PROJECT: Wilton Center Lofts
(12 Godfrey Place)

DATE:	May 31, 2023
TO:	Town of Wilton Planning & Zoning Commission
FROM:	Richard Granoff (Granoff Architects)
REGARDING:	Wilton Center Lofts (12 Godfrey Place) - P&Z Revisions

MESSAGE:	<p>In response to our previous meeting with the Planning & Zoning Commission on 05/22/2023, we have made the following adjustments to the proposed design on the architectural drawings:</p> <p>1) Proposed loading space has been increased from 10'x20' to 10'x30'. Refer to sheets L100, AS100, & A100</p> <p>2) Added clarifications on garage height clearance and drive aisle widths. Refer to sheet A100.</p> <p>3) Reduced number of dwelling units from 42 to 40. There are now 40 dwelling units and 40 standard parking spaces plus 2 HC spaces. Refer to sheet AS100 for unit mix updates and sheet A102 for proposed floor plan updates.</p>
-----------------	--

DRAWING TITLE
LANDSCAPE PLAN

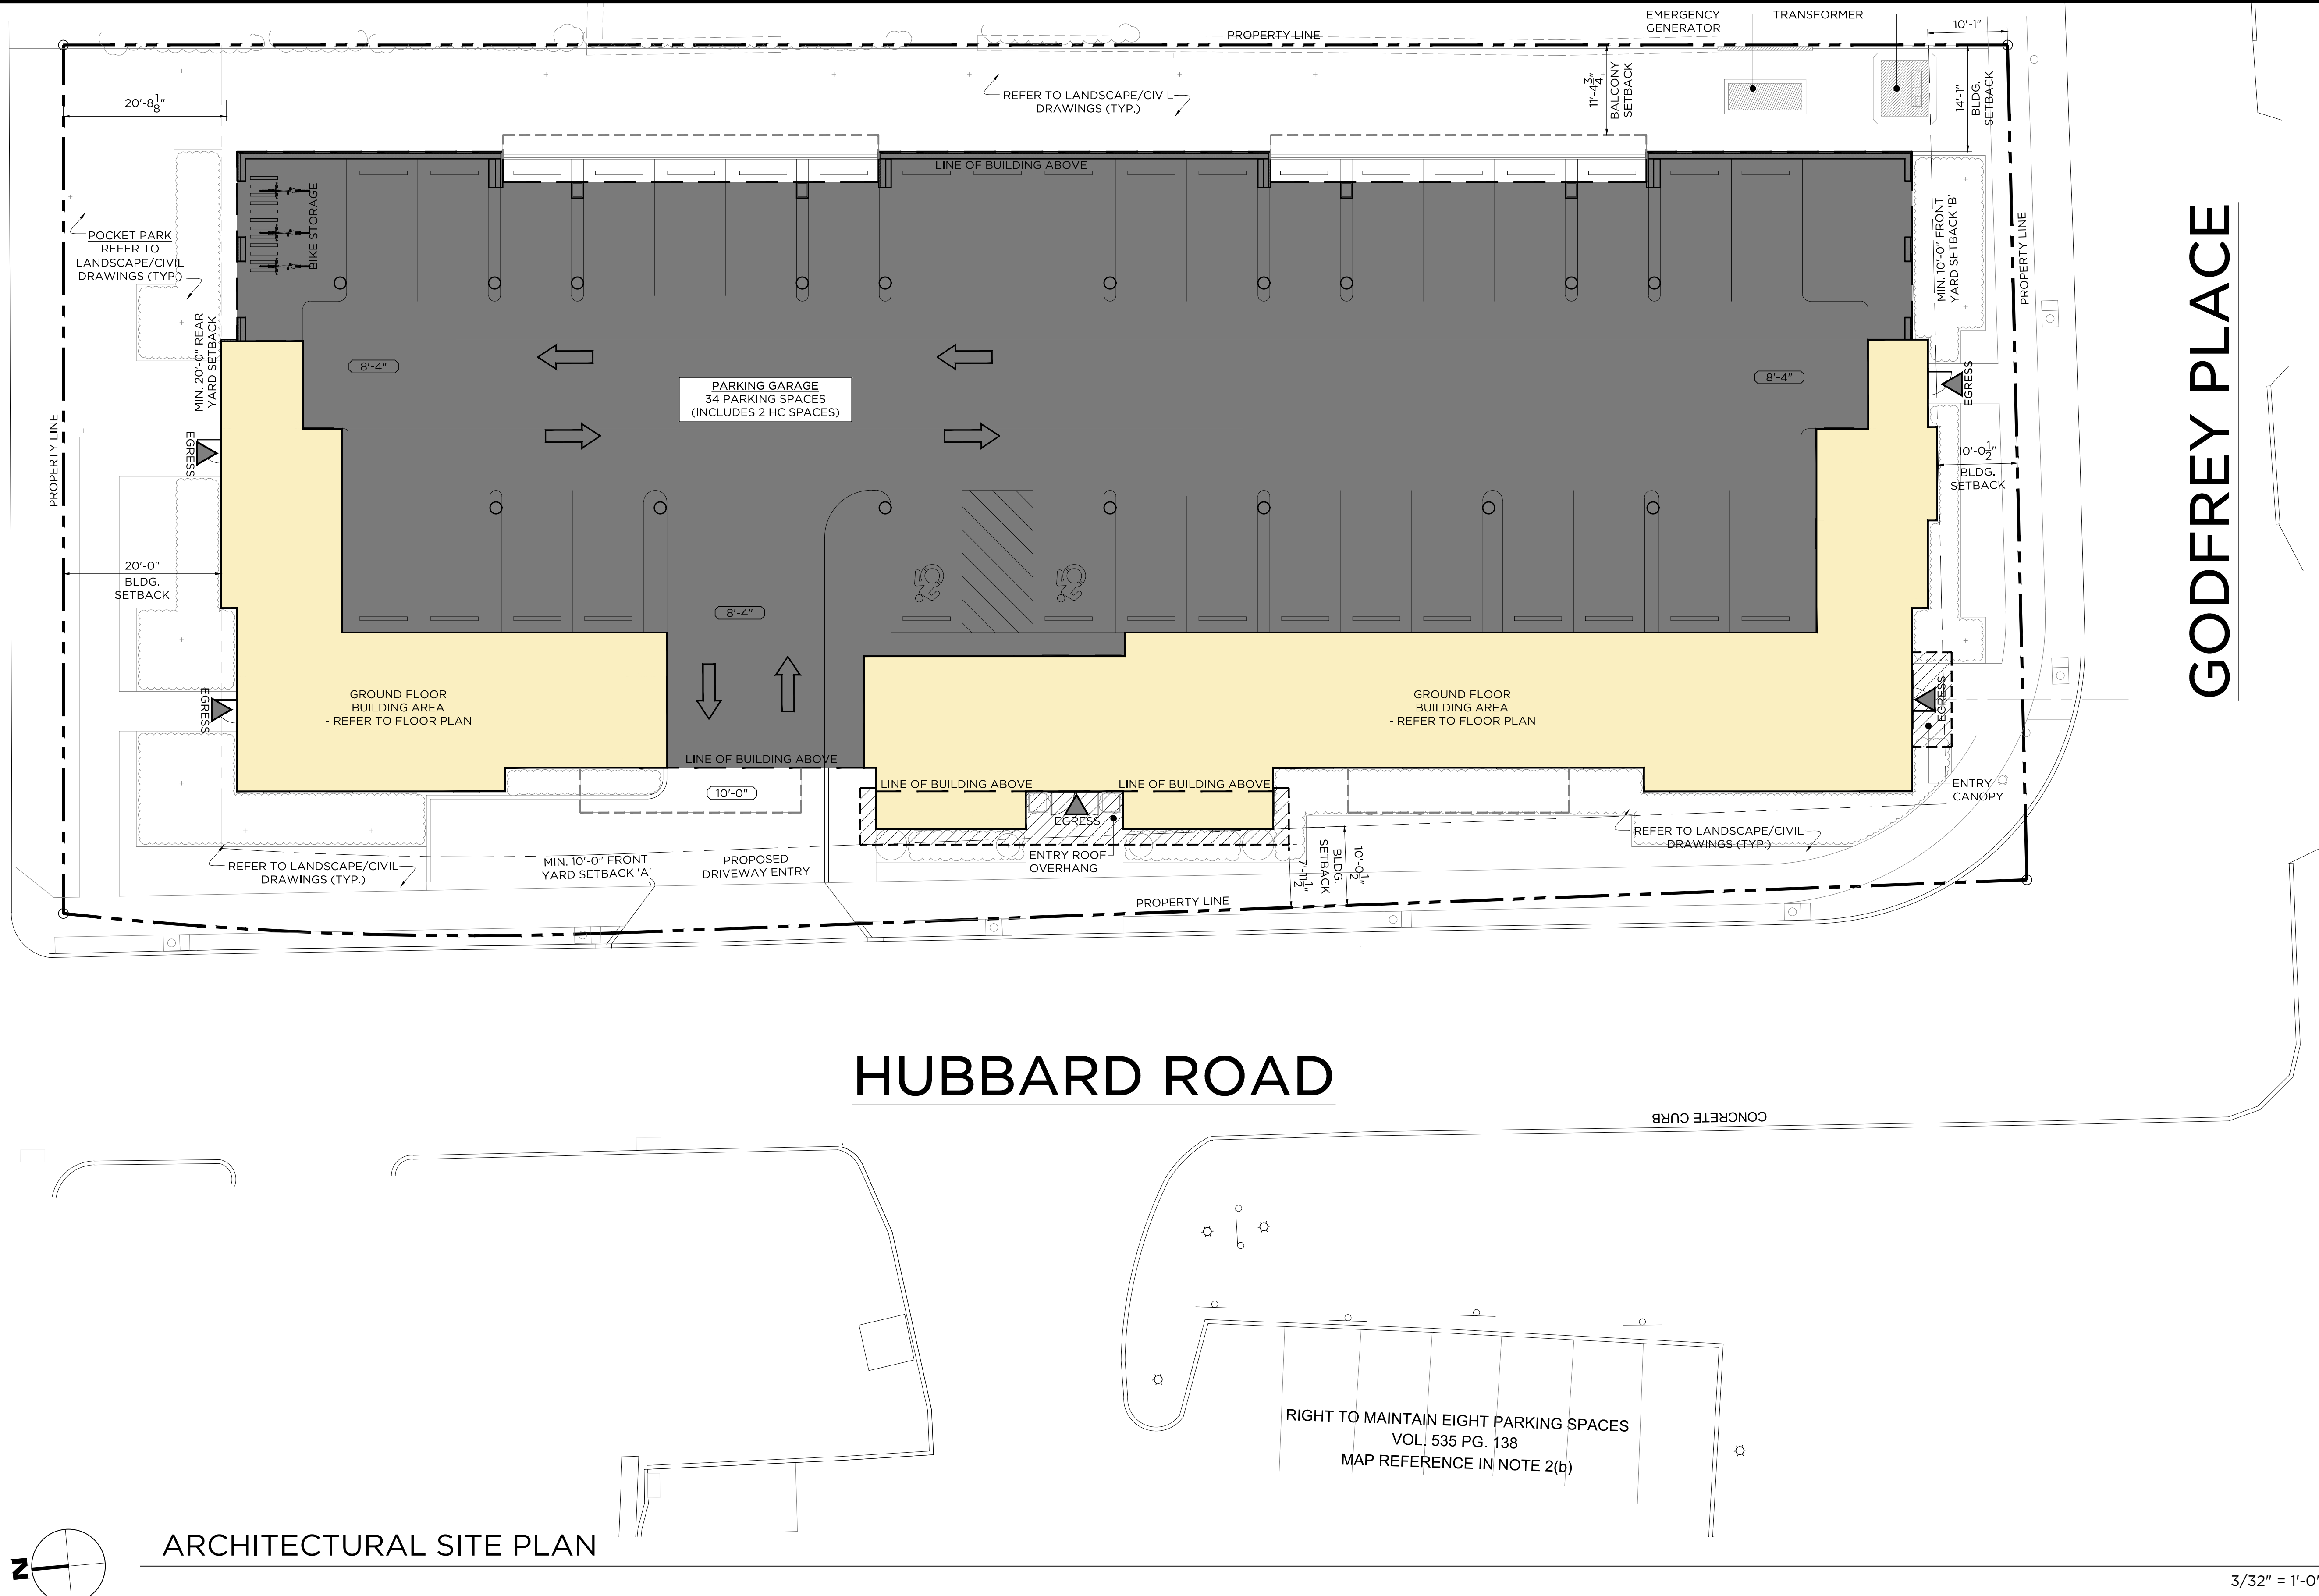
REVISIONS				
#	DATE	REVISION DESCRIPTION	BY:	
1	05.15.23	LOADING ZONE		
2	05.26.23	LOADING ZONE
